Part 2 - Regulation 19 and 20 of the Town and Country Planning (Local Planning) (England) Regulations 2012 "Pre-Submission LDP" consultation

**Response to Consultation regarding Maldon's Local
 Development Plan**

On behalf of Little Baddow Parish Council, I wish to comment specifically on the conclusions of your document "*Technical Note – Impact of Proposed Development Sites in Heybridge and South Maldon on Wider Highway Network*" dated December 2013 under reference EB004b (hereafter called "The Report").

Diagram A

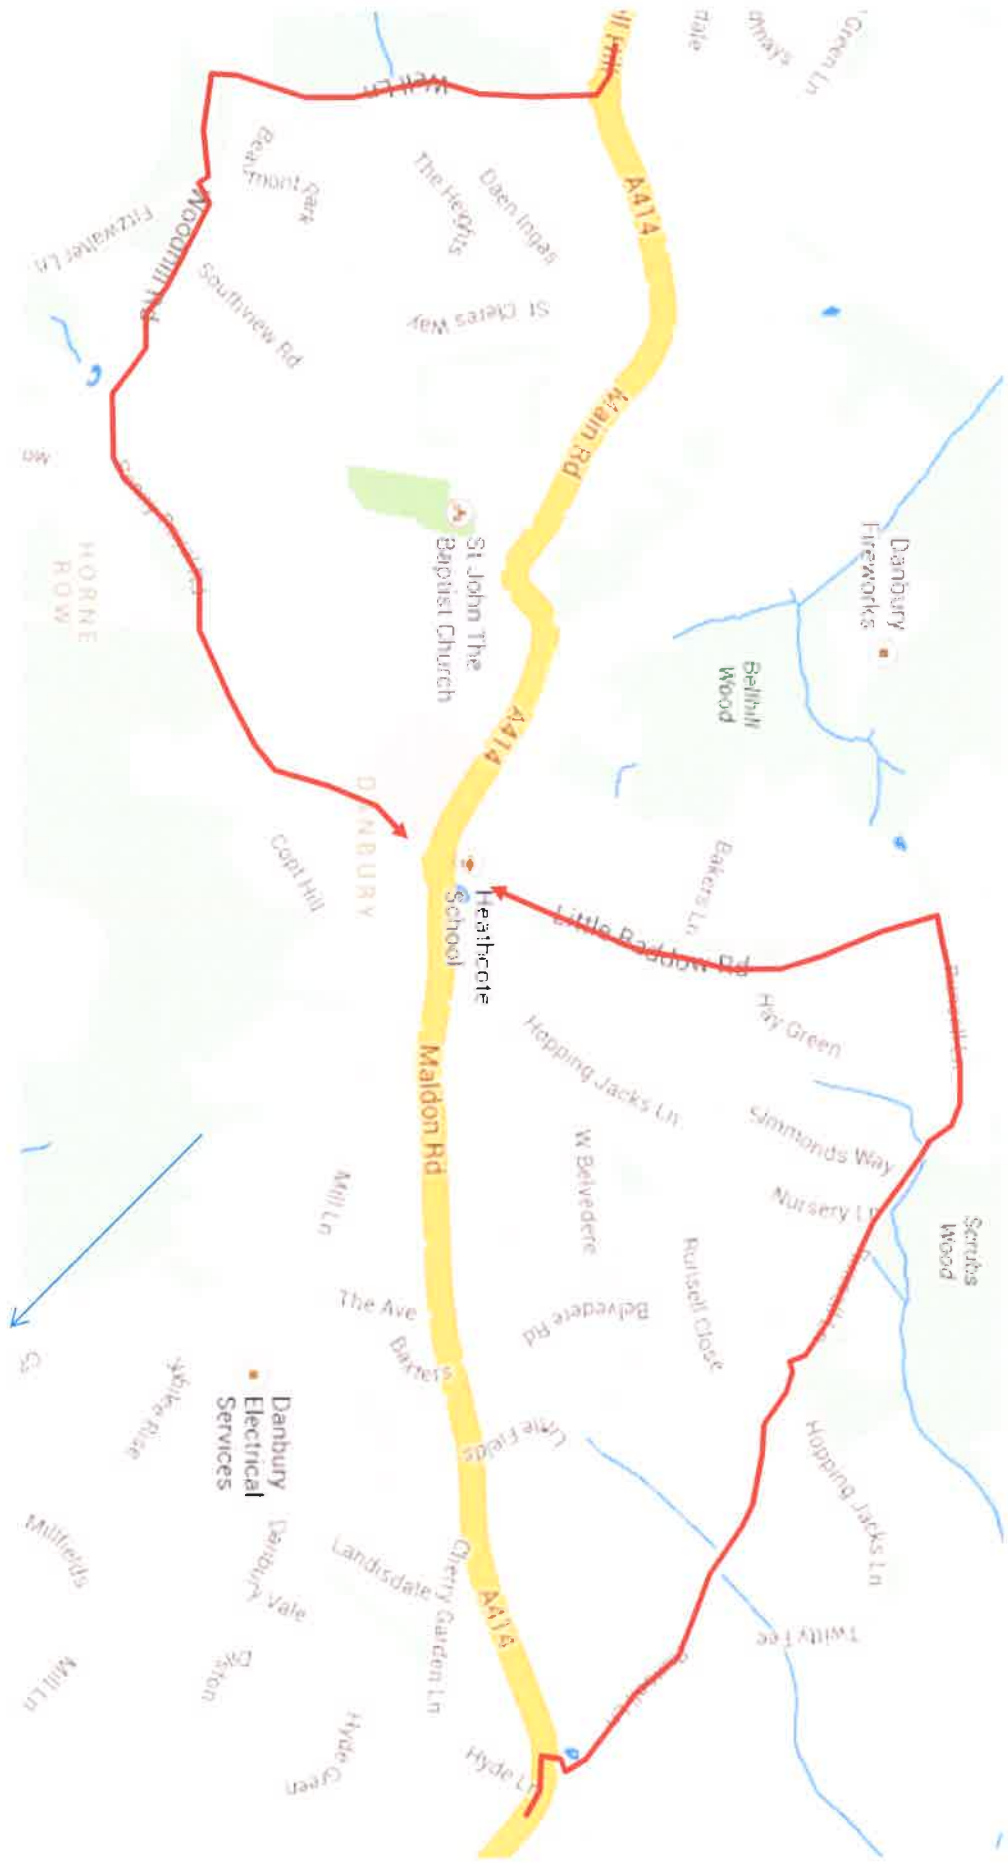
At present, there are 2 areas in Little Baddow Road where on-road parking reduces the available road to a single lane –

- The first of these starts some 50 yards from the mini-roundabout junction, where residential on-road parking on the west side of the road already makes it difficult for cars travelling from Eves Corner towards Little Baddow to proceed in the face of oncoming traffic. It extends up to, and sometimes beyond, the point where Butts Lane joins Little Baddow Road. This can be exacerbated by short-term (illegal) parking of cars even nearer to Eves Corner on the double yellow line outside Barclays Bank, and by cars negotiating entry to and exit from the parking area in front of the shops opposite the bank on the short road called "Eves Corner".
- The second area often reduced to a single lane extends between the junctions with Little Baddow Road of Butts Lane

and Hay Green, caused by a large number of cars parking on the east side of Little Baddow Road for the "school run" and other school activities at different times. There is no alternative safe parking solution for parents.

The areas in question are as set out in [Diagram A](#).

Given that the modelling of standard signalling at the junction indicates a peak load of 36.9 pcu's (personal car units) queuing towards the A414, then unavoidably the queue which would form would completely block vehicles attempting to proceed down Little Baddow Road **away** from Eves Corner. This would be exacerbated by traffic struggling to pass through or park in the road called "Eves Corner" between the parade of shops and the Village Green.
